ADDENDUM NO. 04

Project: Arthur Area Community Centre Renovation

ADDENDUM 02

MECHANICAL

PARTIAL SECOND FLOOR POWER & SYSTEM RENOVATION PLAN
SCALE: 1/8"=1'-0"

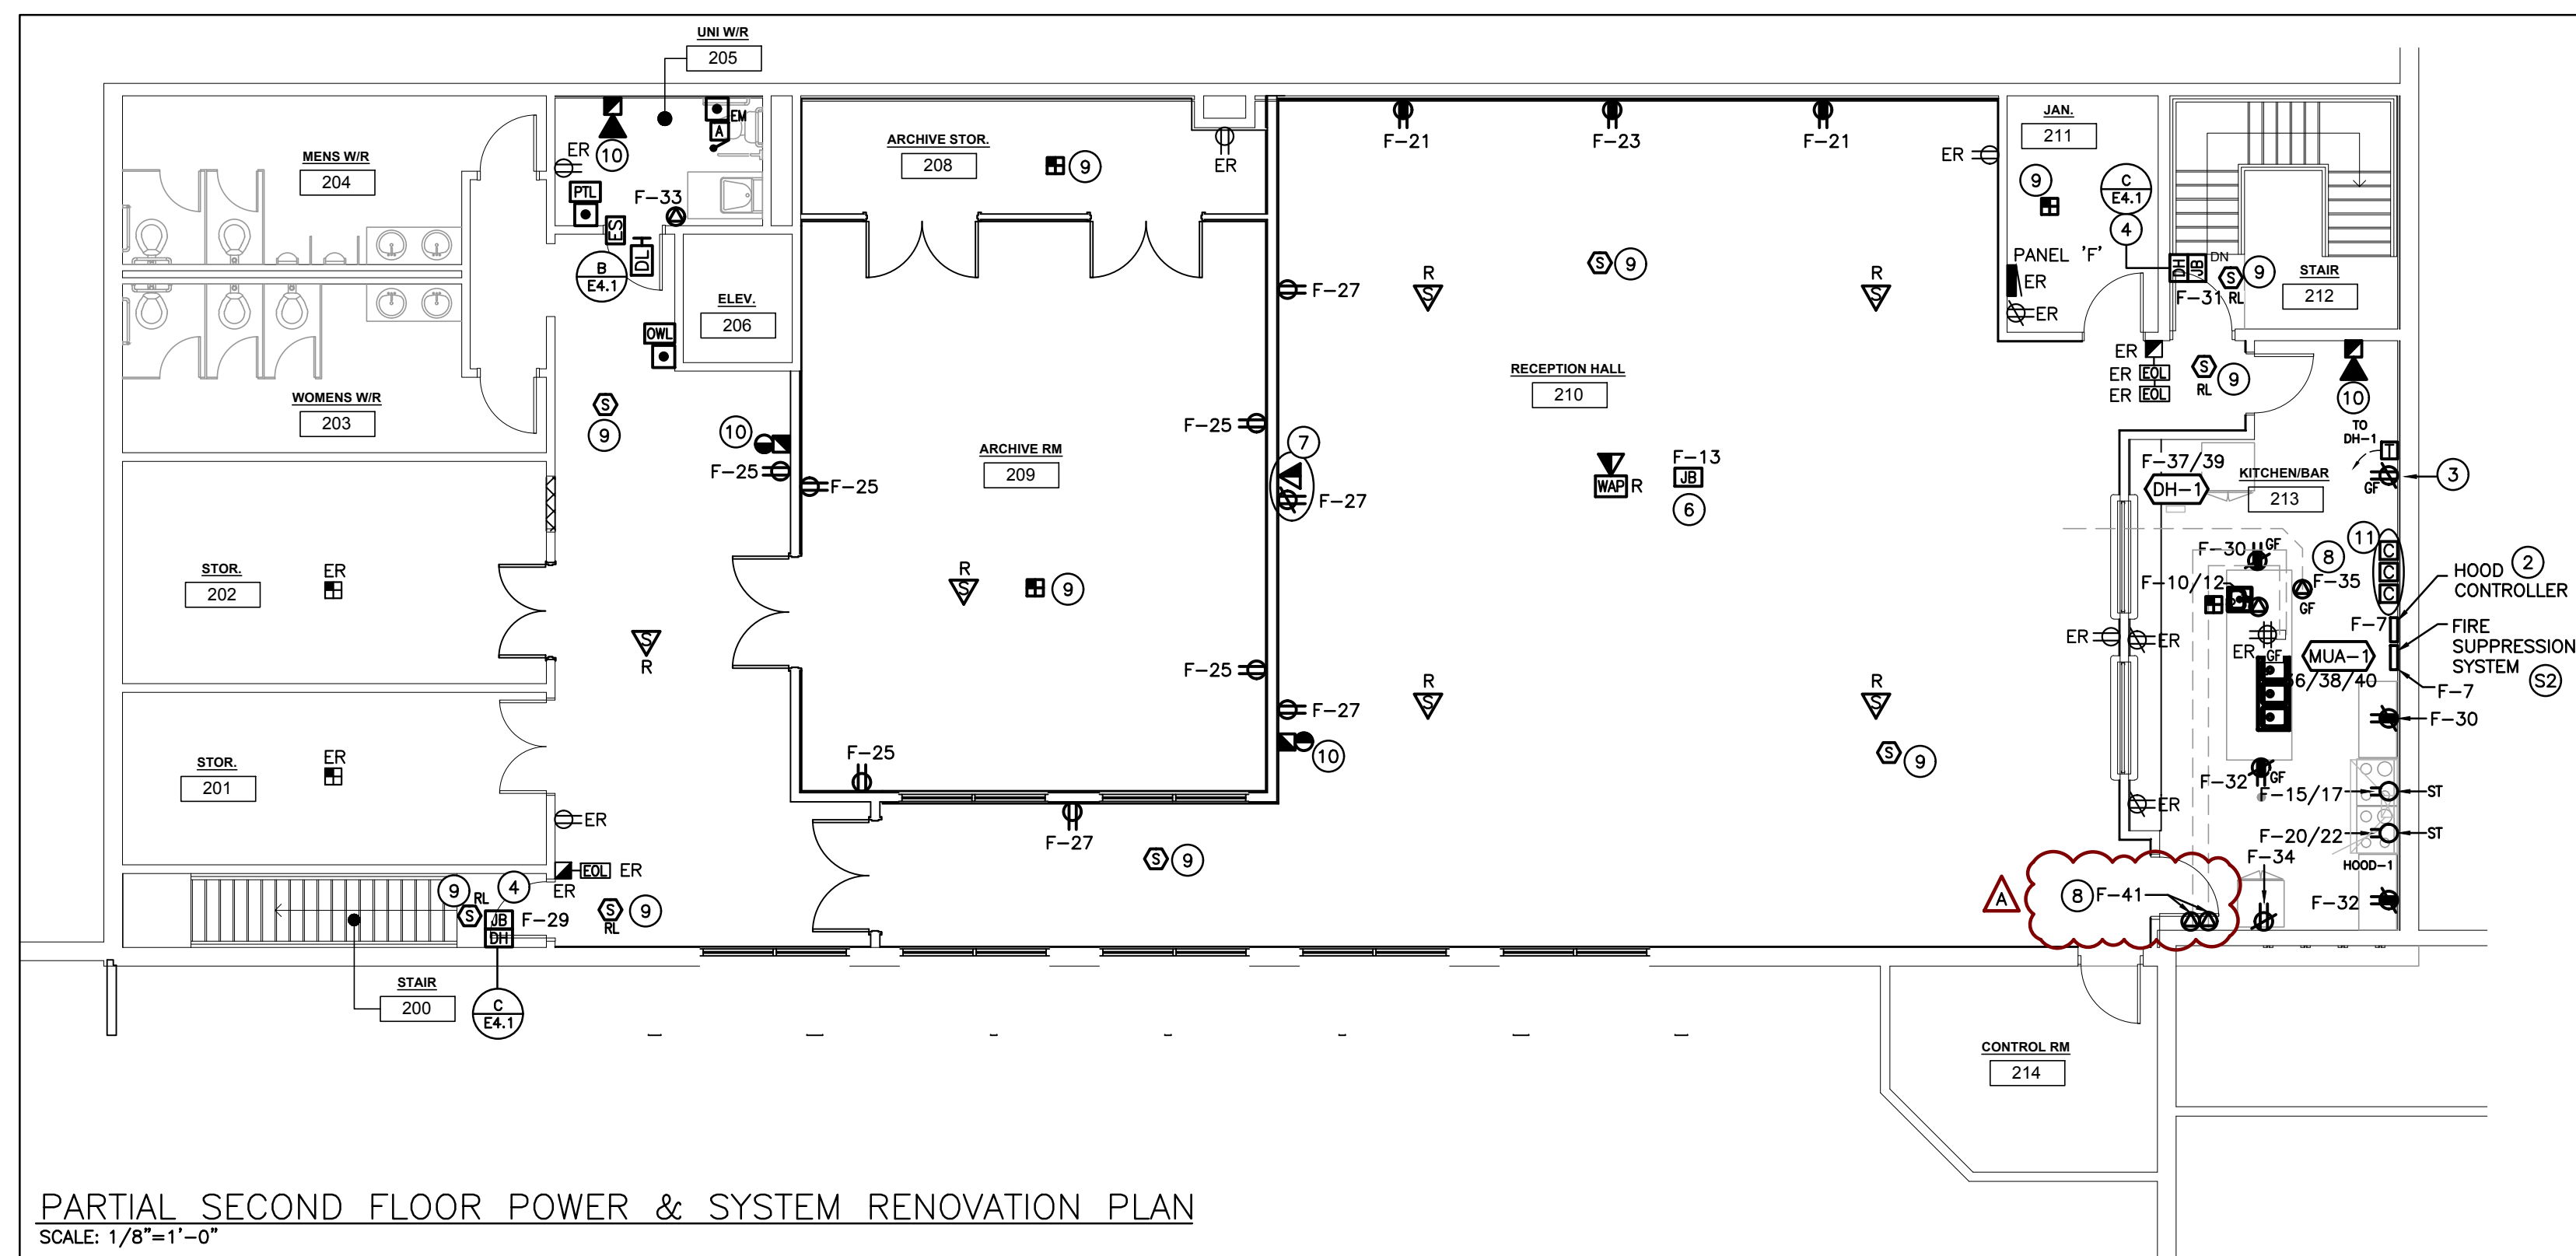
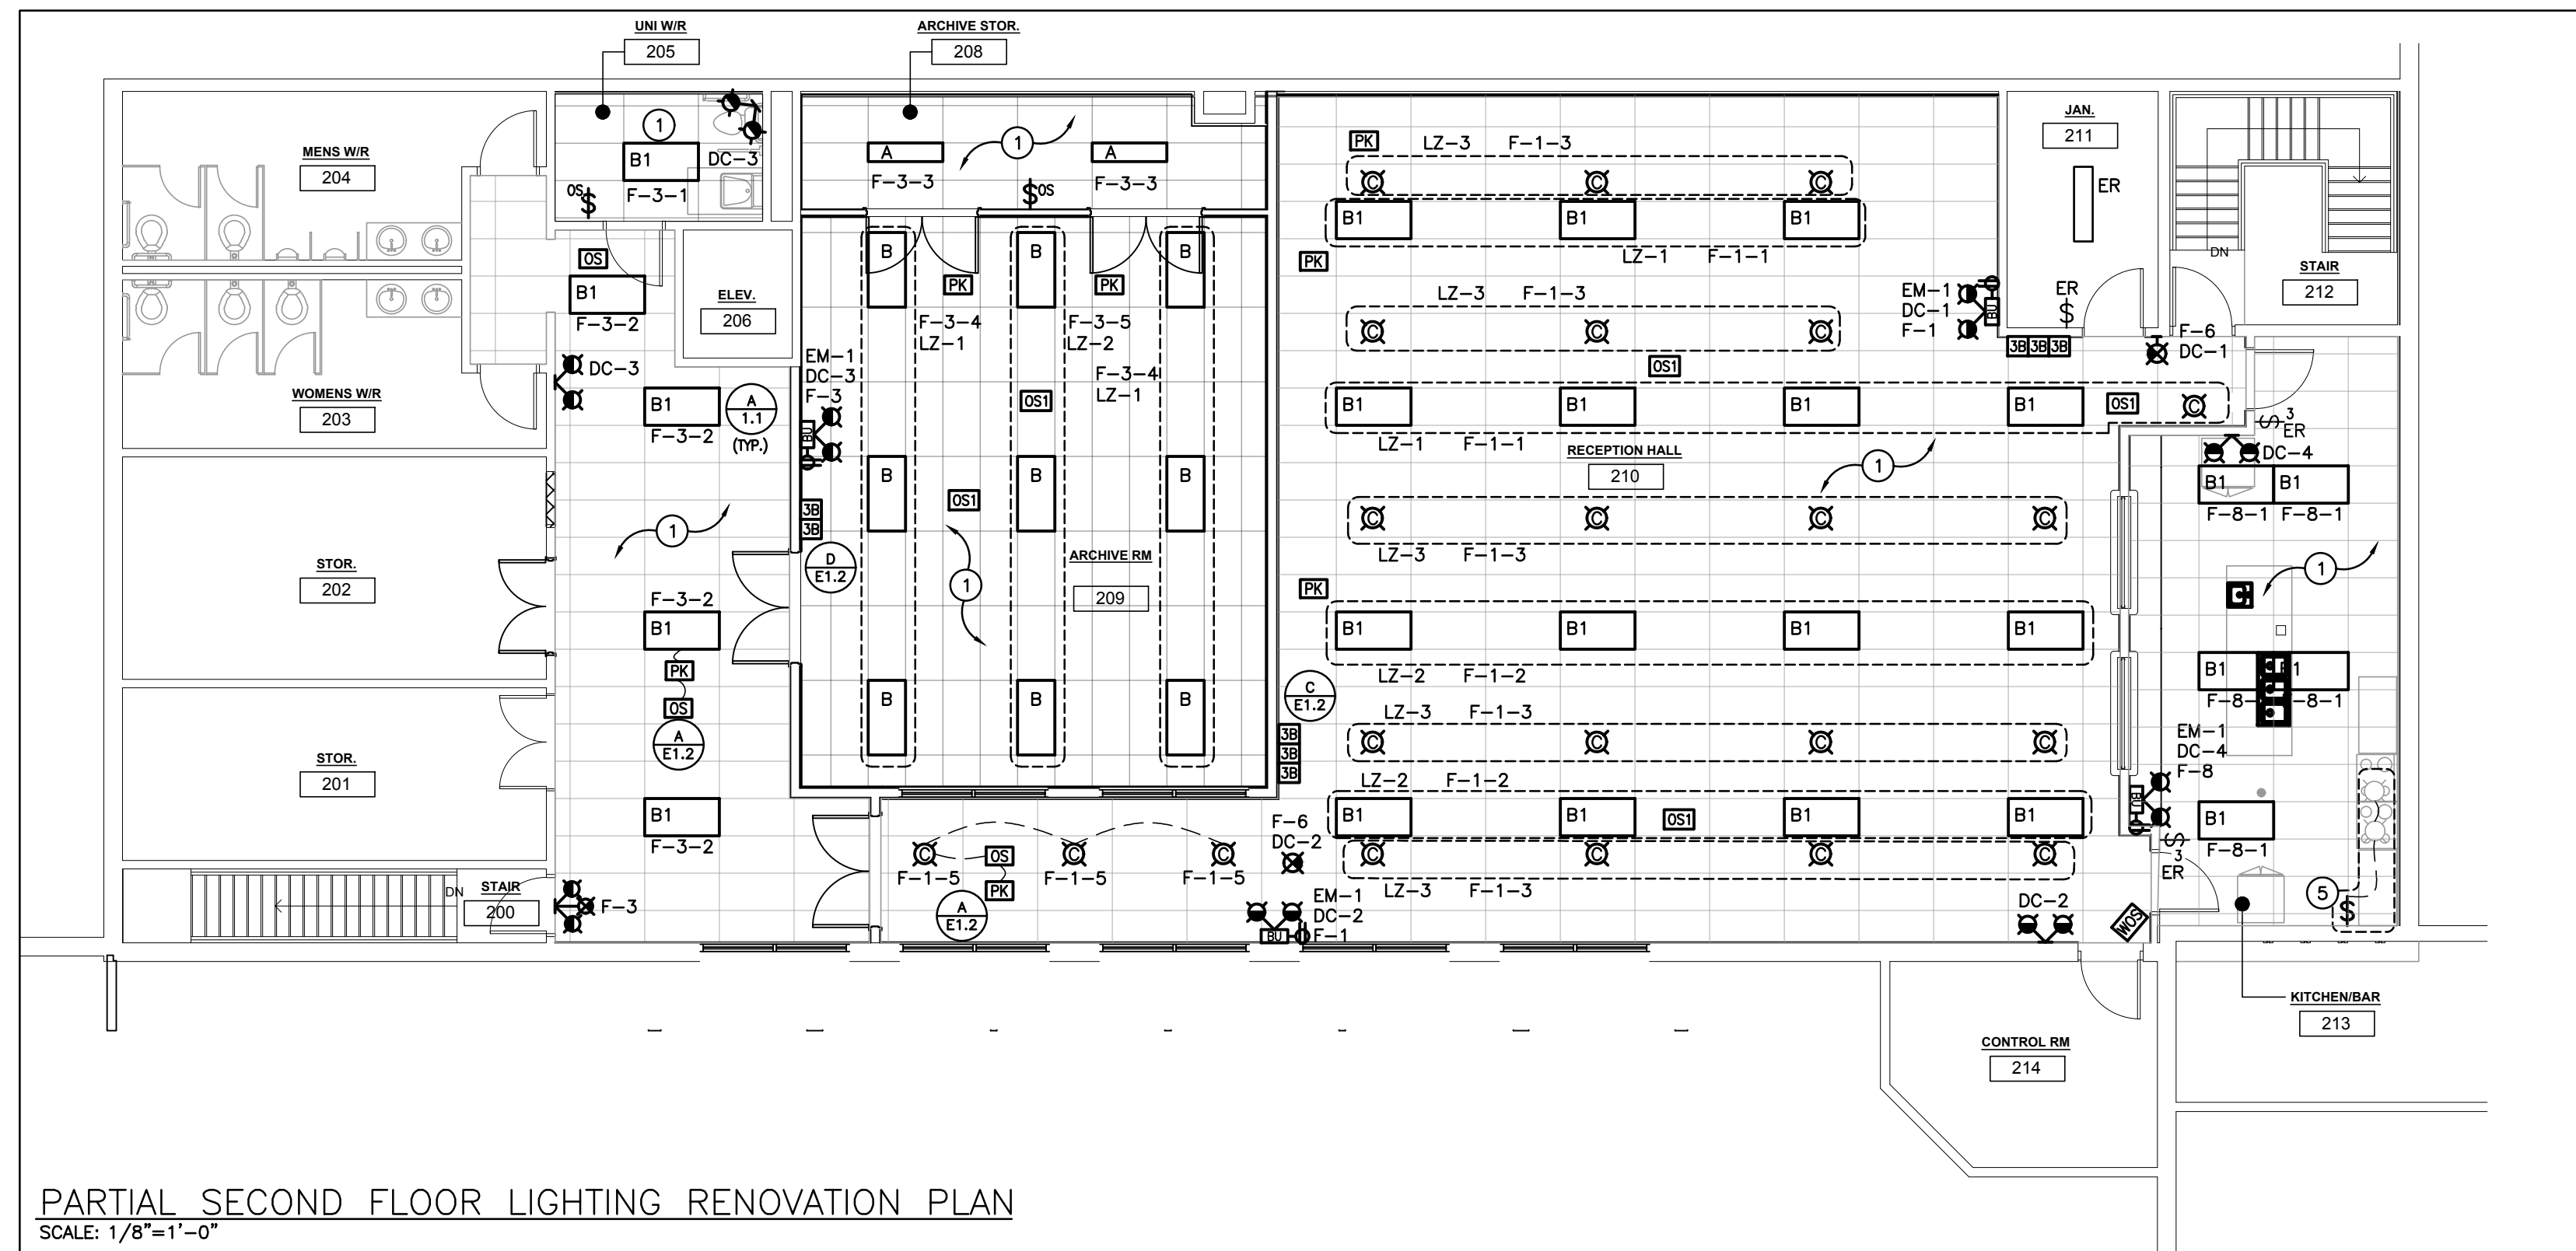
- 1.0 Reference Attached Reissued Drawing E2.2
.1 In Kitchen/Bar '213', provide connection for heat trace of hot and cold water lines.

**ARTHUR ARENA
 INTERIOR
 RENOVATIONS
 158 DOMVILLE ST.
 ARTHUR, ONTARIO
 PARTIAL ROOF PLAN
 AND PANEL
 SCHEDULE**

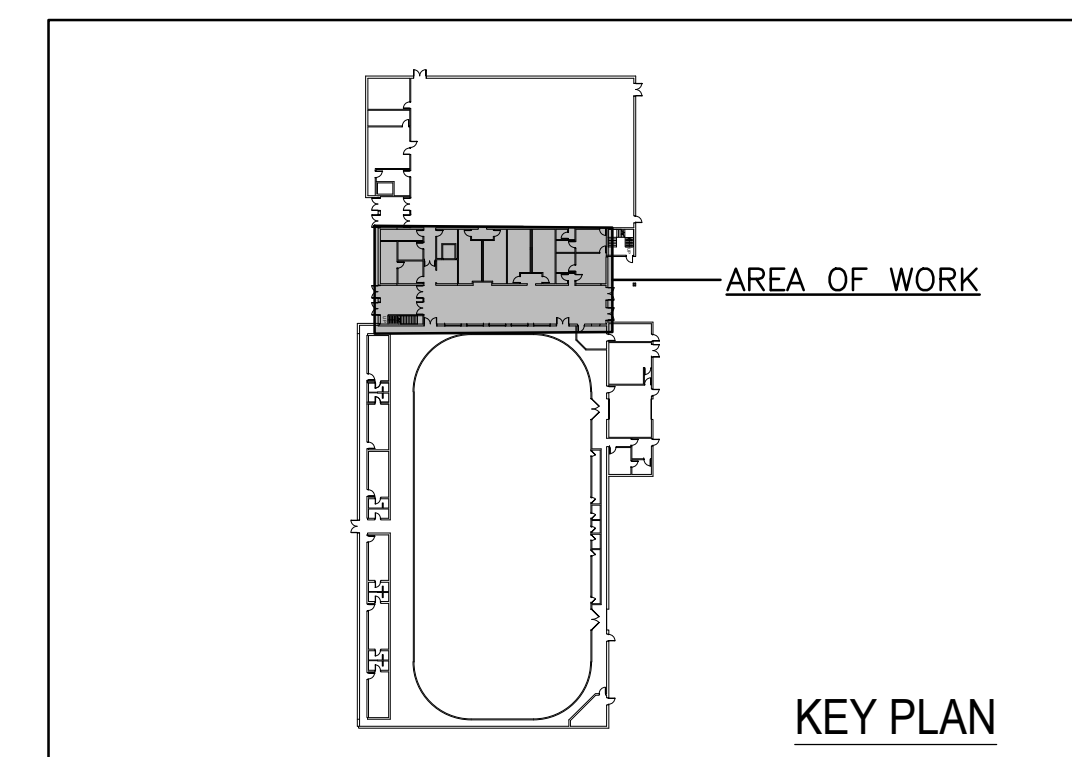
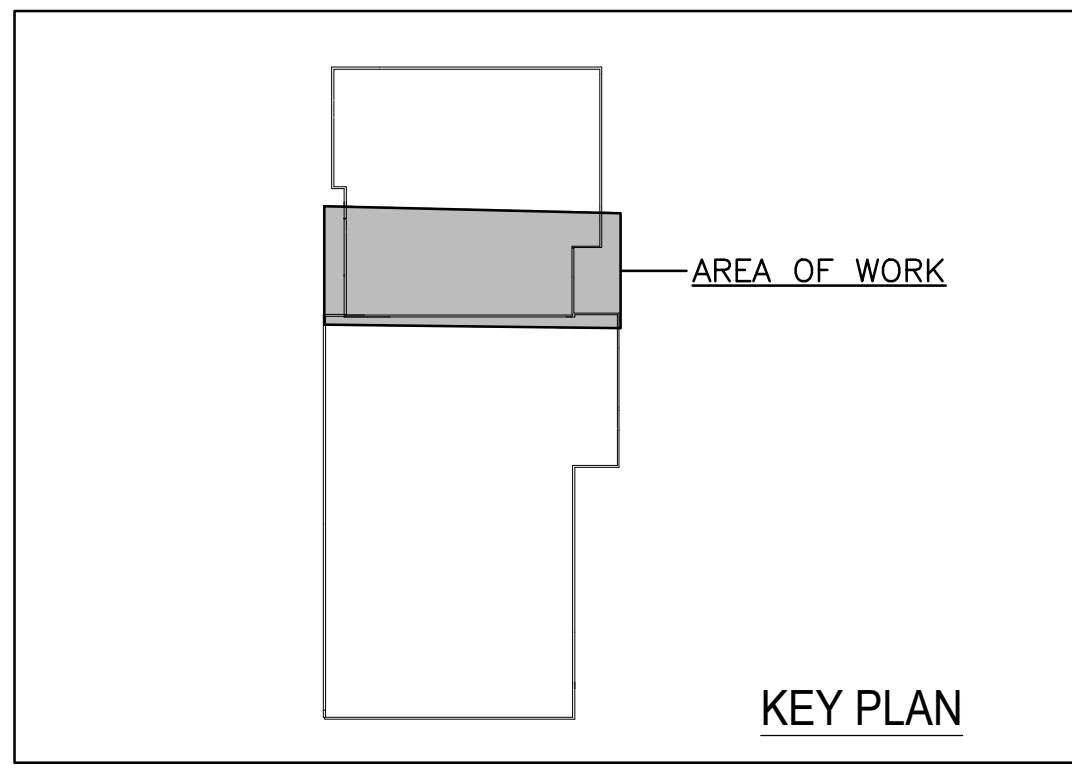
- .1 Within existing Panel 'F', provide one (1) 15A-1P 33mA ground-fault breaker at CCT - #41 for heat trace. Update panel directory as shown.
